#### CHARTER TOWNSHIP OF VAN BUREN PLANNING COMMISSION AGENDA Wednesday, October 13, 2021 – 7:30 PM REMOTE MEETING –AGENDA

# ITEM # 1 Case 21-021- General Development Company, LLC - Special Land Use request

#### ITEM # 2 Case 21-021- General Development Company, LLC – Preliminary Site Plan

TO:Van Buren Township Planning CommissionFROM:Dan Power- Director of Planning and Economic DevelopmentRE:Case 21-021: General Development Company, LLC - Special<br/>Land Use and Preliminary Site Plan RequestDATE:October 6, 2021

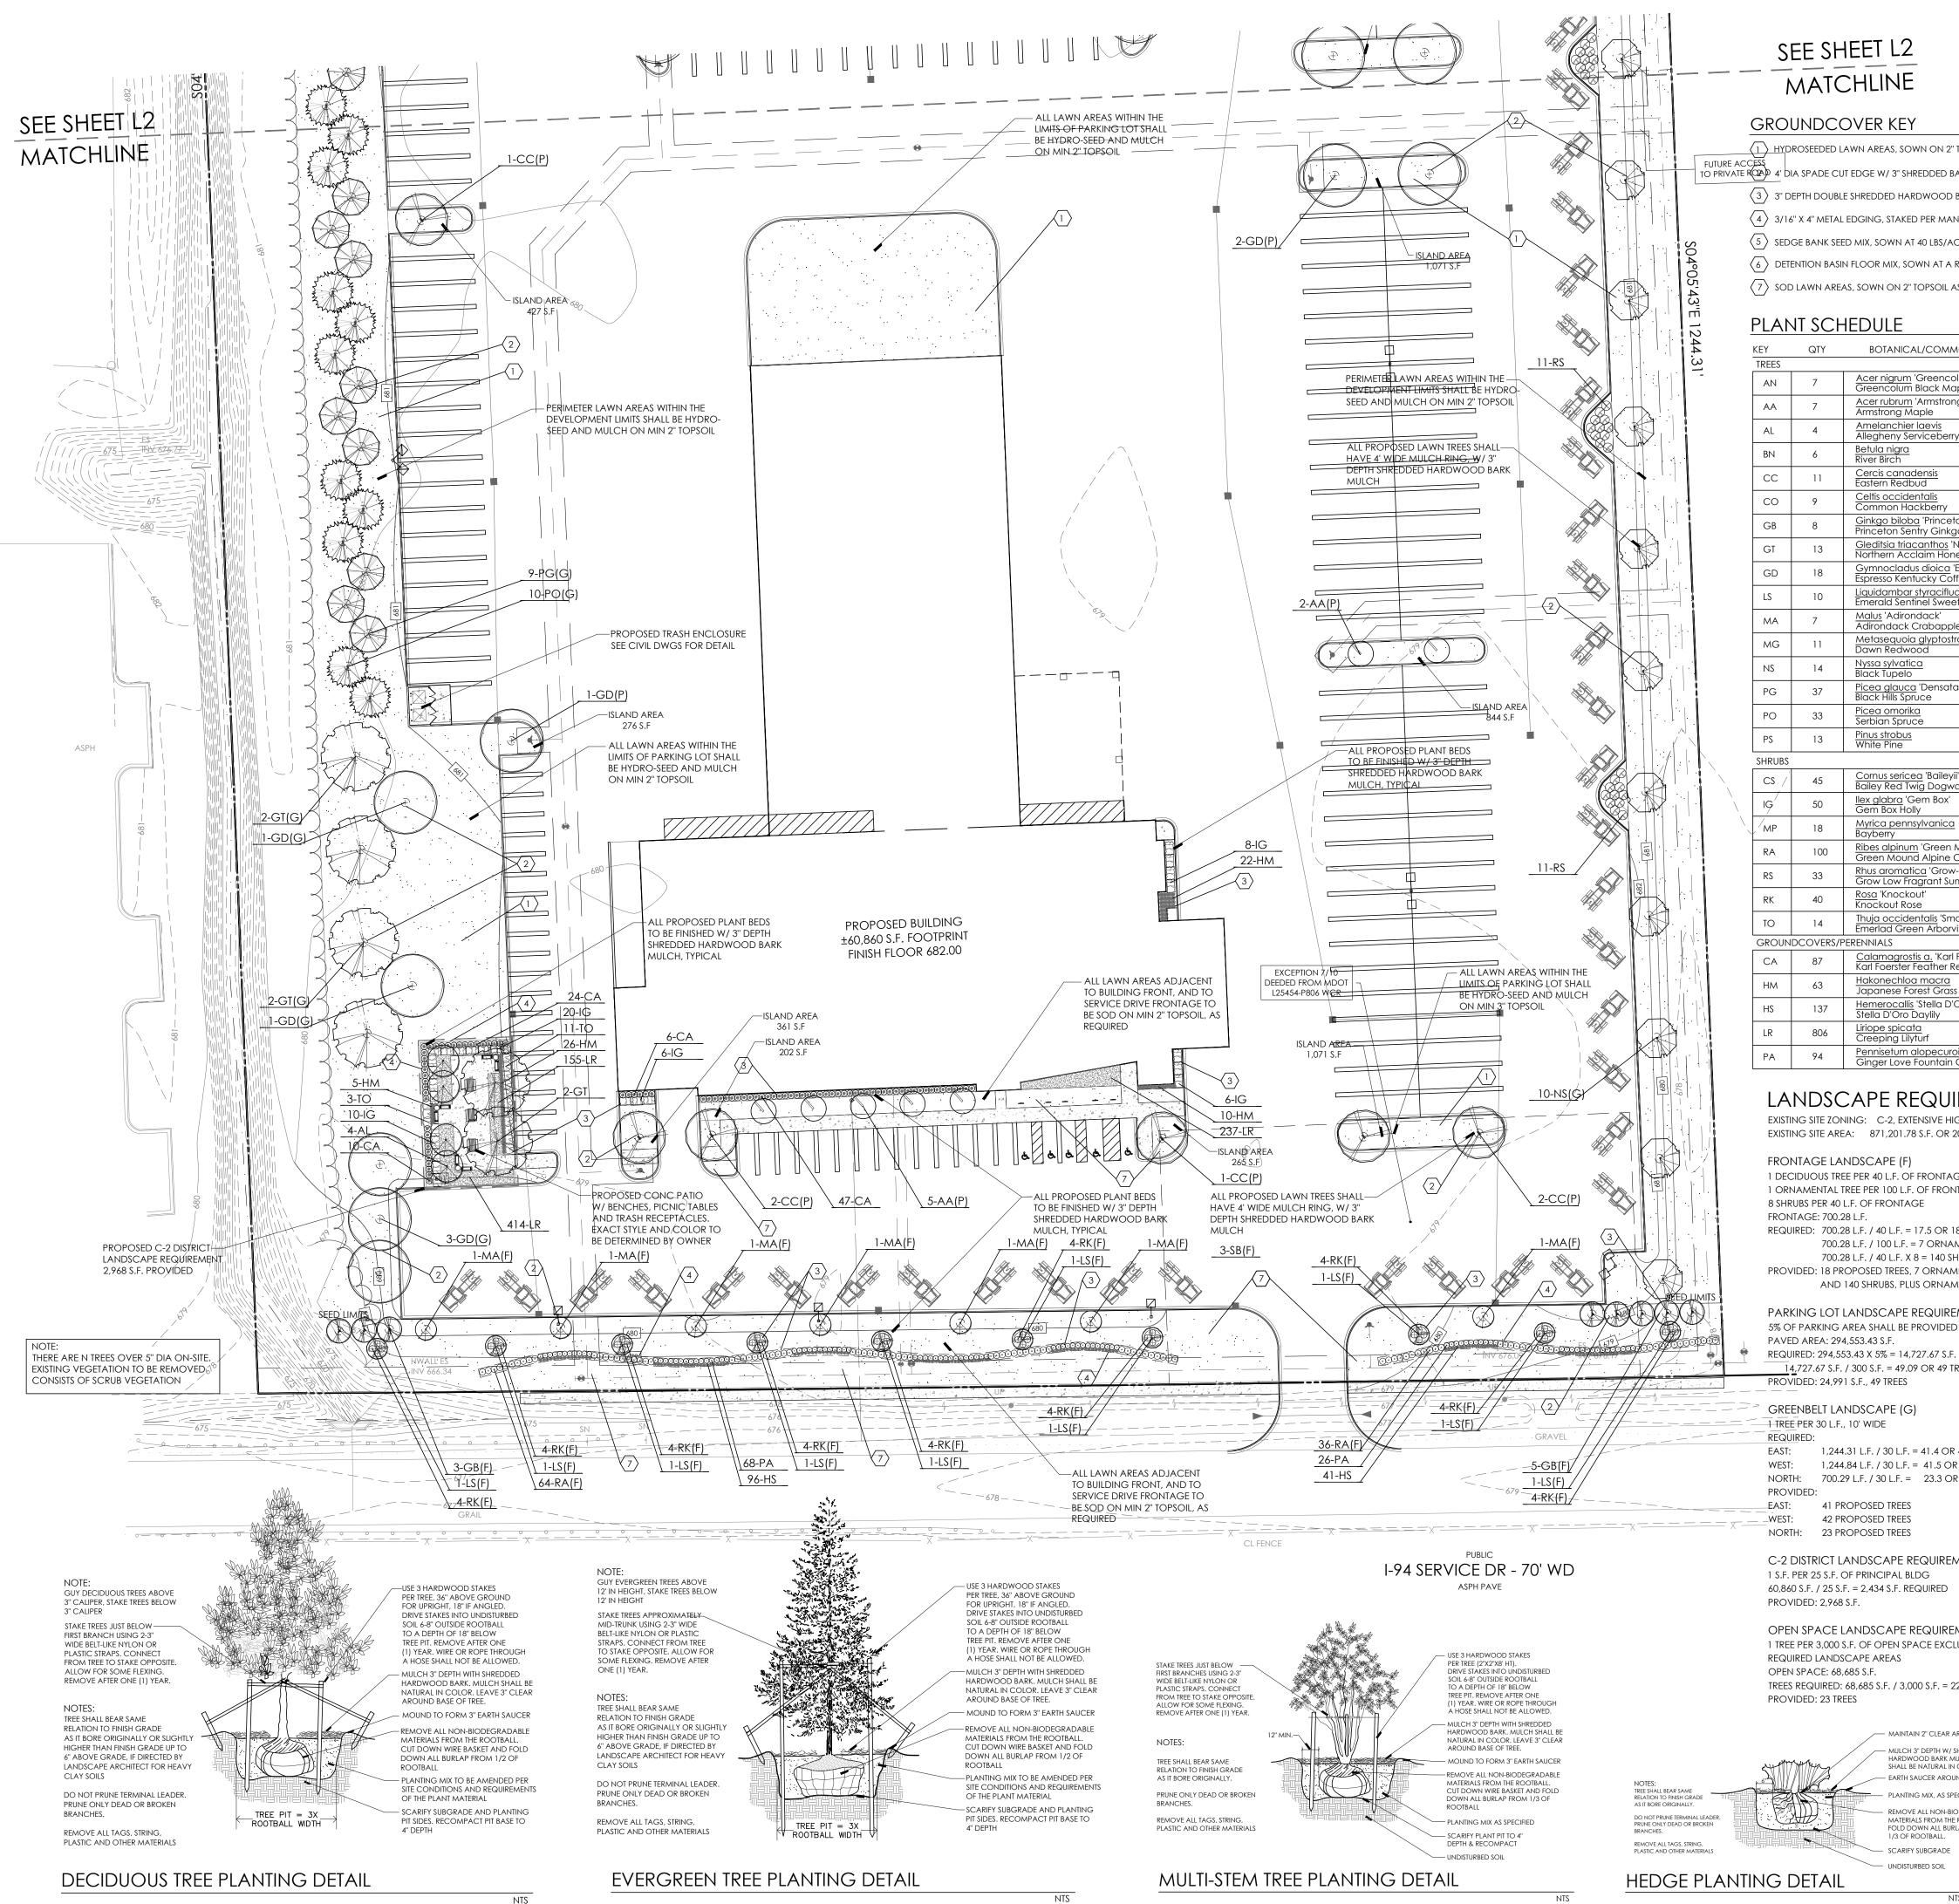
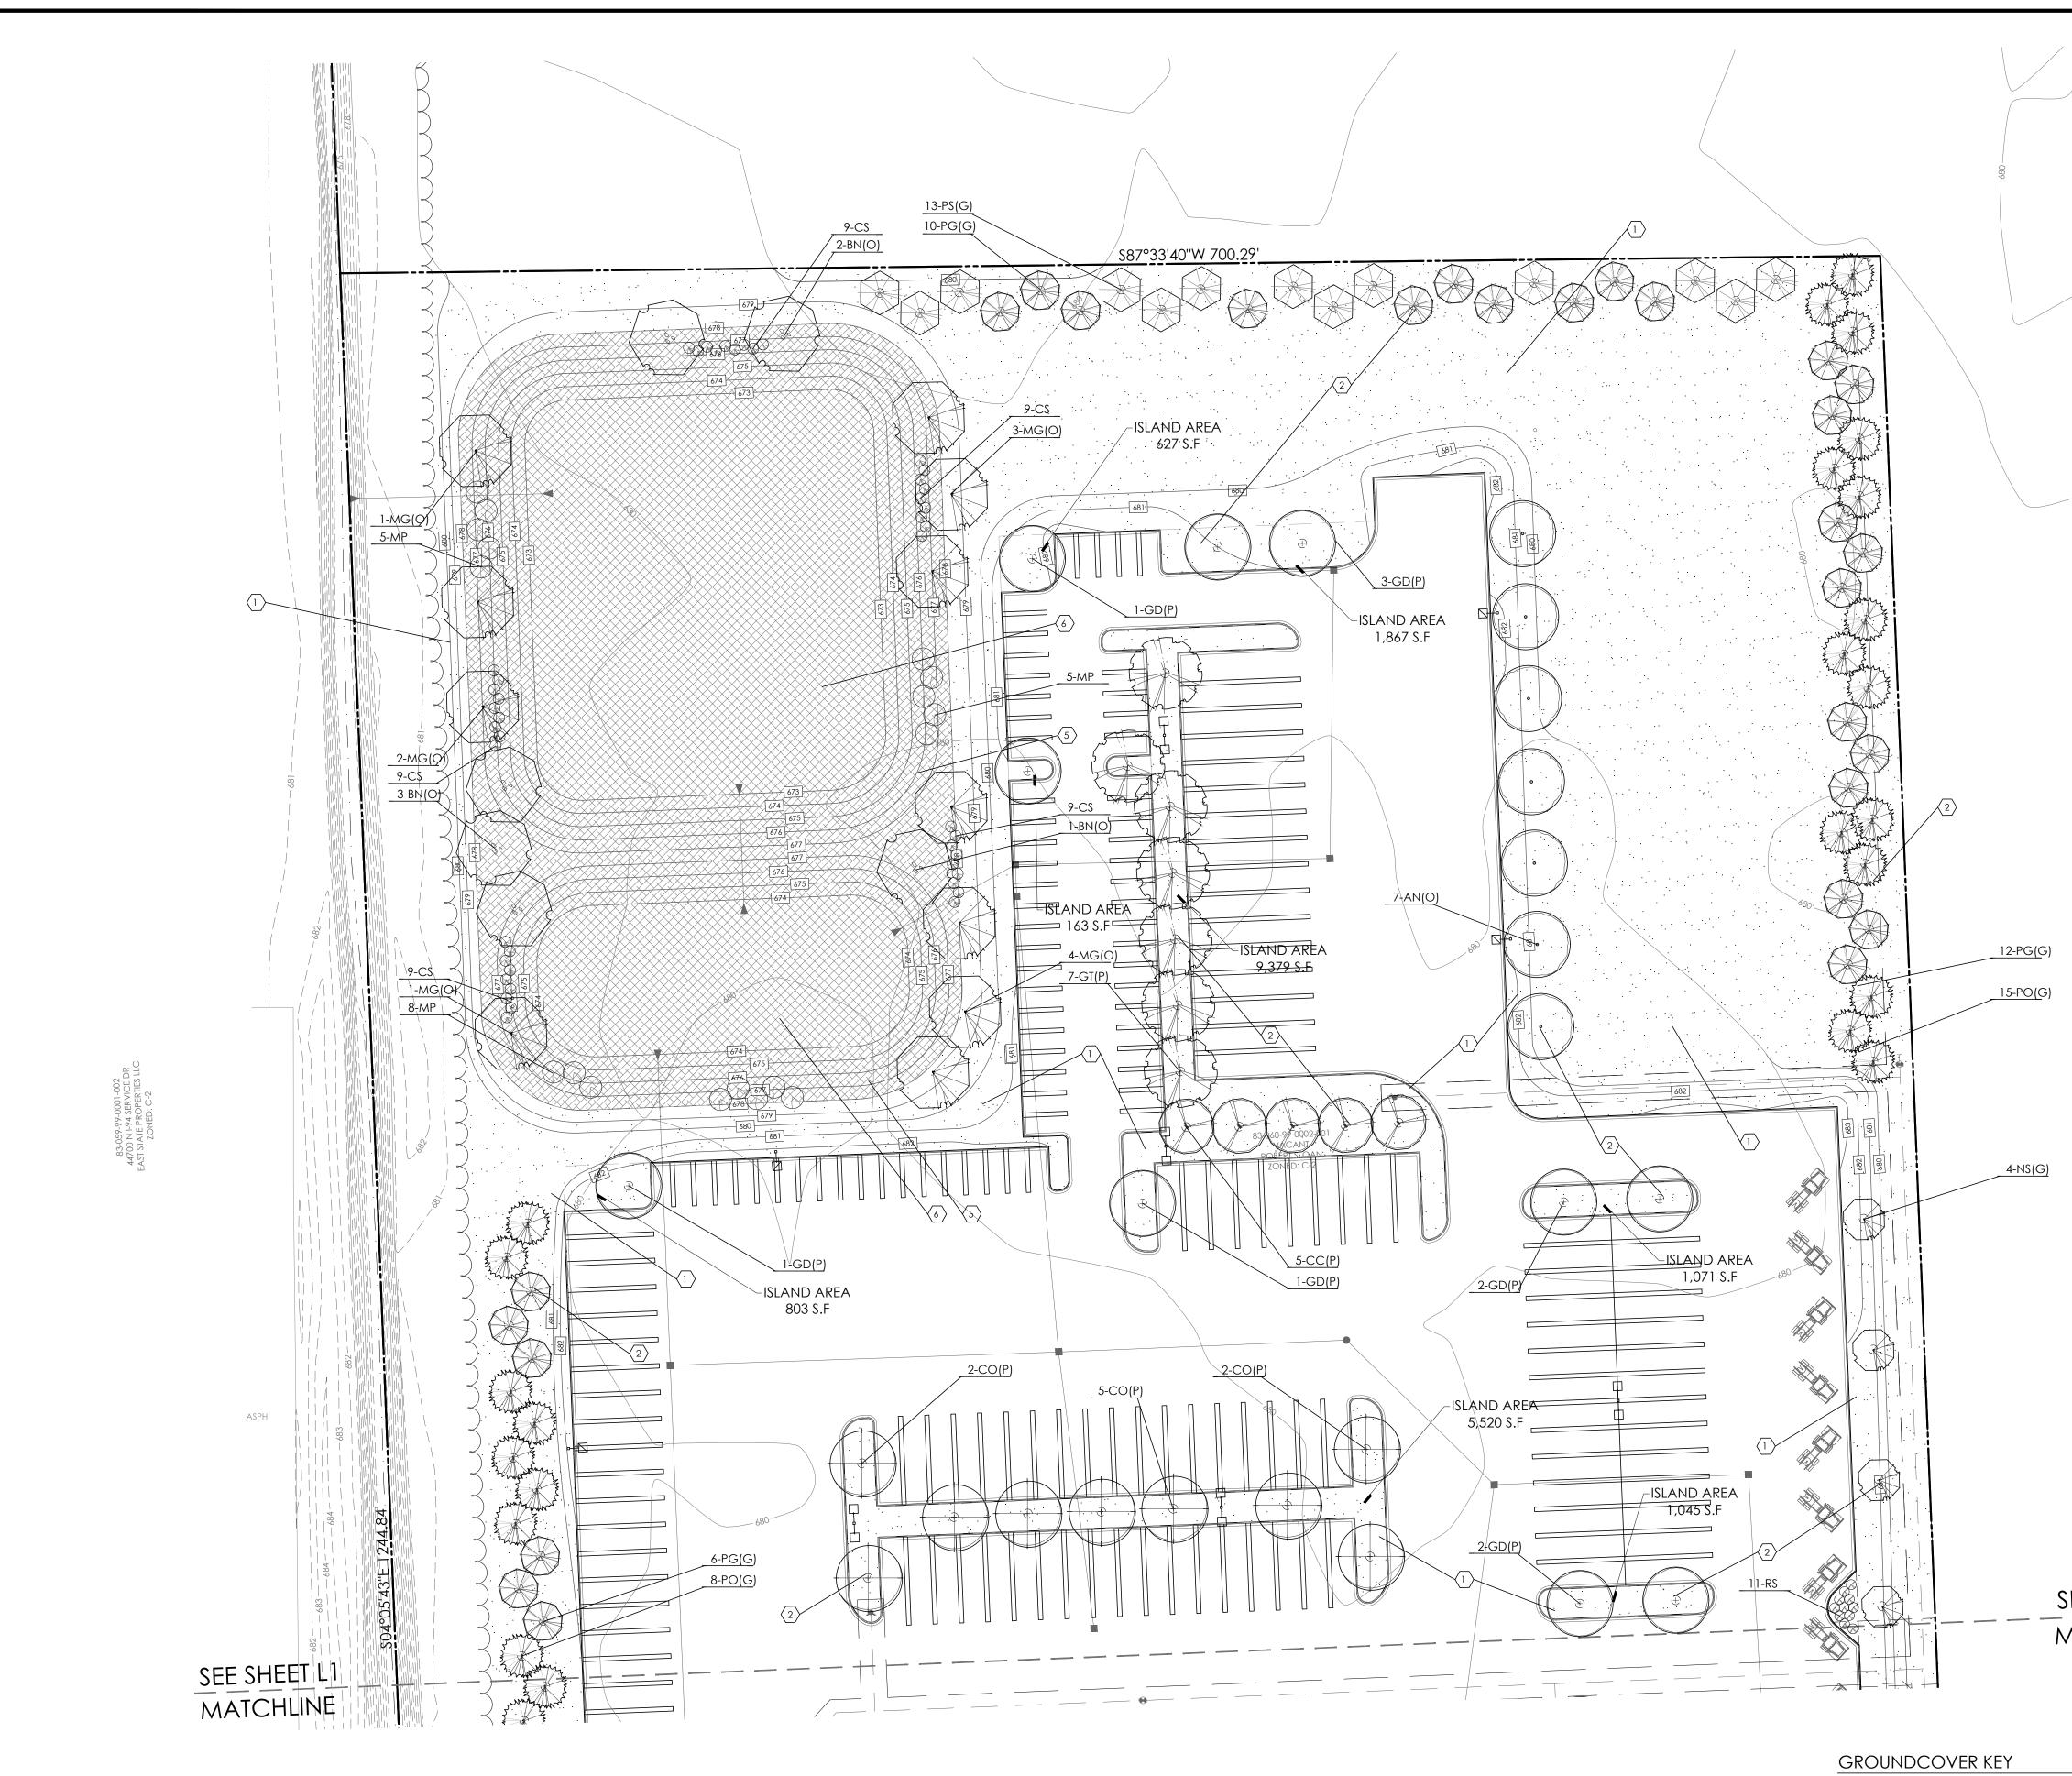
- 6. General Plan Comments;
  - a. The Cover Sheet should include a listing of permits required.
  - b. Some of the notes on landscape plan (sheet L1) are covered with linework and should be clarified.
